OHIO TURNPIKE AND INFRASTRUCTURE COMMISSION

ADDENDUM NO. 1 **ISSUED JANUARY 10, 2020**

PROJECT NO. 39-20-02 (PART A) MAINLINE PAVEMENT RECONSTRUCTION MILEPOST 46.50 TO MILEPOST 50.92 **FULTON & LUCAS COUNTIES, OHIO ISSUED DECEMBER 30, 2019**

PROJECT NO. 39-20-02 (PART B) TOLL PLAZA 49 SITE CONSTRUCTION MILEPOST 48.8 TO MILEPOST 49.1 LUCAS COUNTY, OHIO **ISSUED DECEMBER 30, 2019**

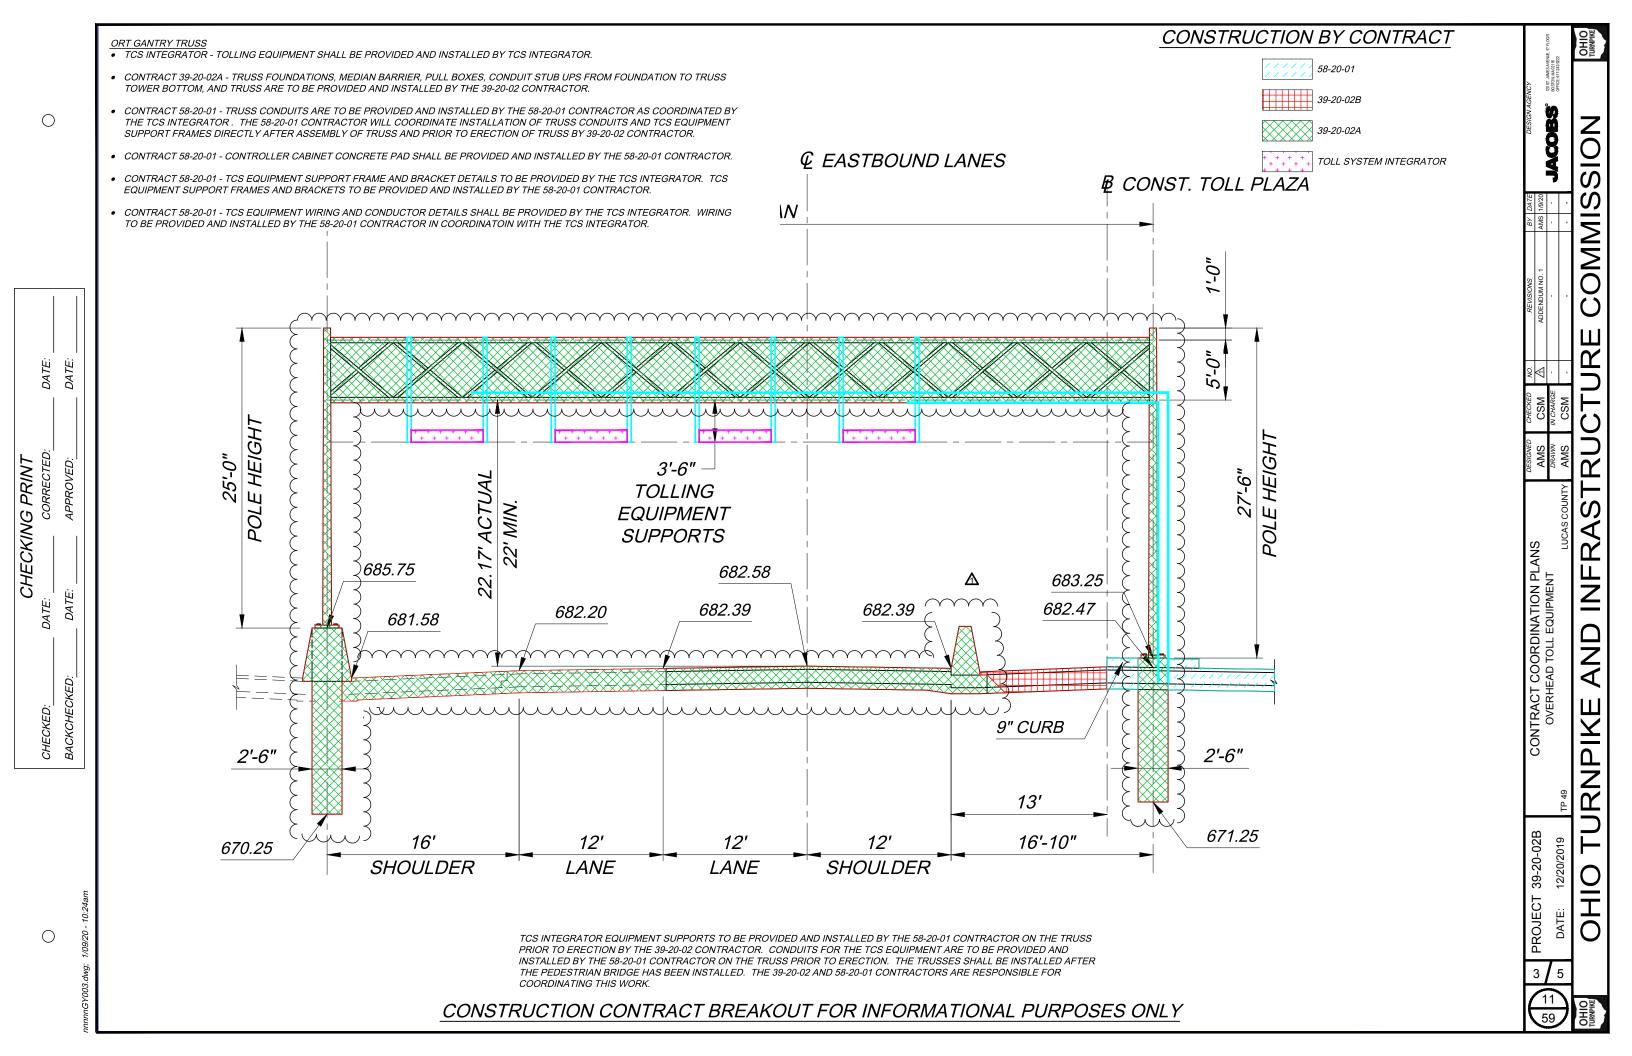
- Q#10 Bid item 110 Catch Basin #8: proposal and general summary call these out as #8 catch basins. Plan sheets 207 (D-34) and 208 (D-42) show these as #6 Catch Basins. The attached ODOT standard drawings are for #6 but not #8 Catch Basins. Please review and clarify if these Catch Basins are to be #6 or #8.

- A#10 This Addendum No. 1 revises General Summary Sheet No. 171 of 505 and Drainage Sub Summary Sheet Nos. 177 and 178 of 505 to change the Catch Basin No. 8 designation to Catch Basin No. 6.; and revises Reference No. 110 on the Estimated Quantities Worksheet to change the Catch Basin No. 8 designation to Catch Basin No. 6. There is no change in quantity for this item as a result of this Addendum No. 1.
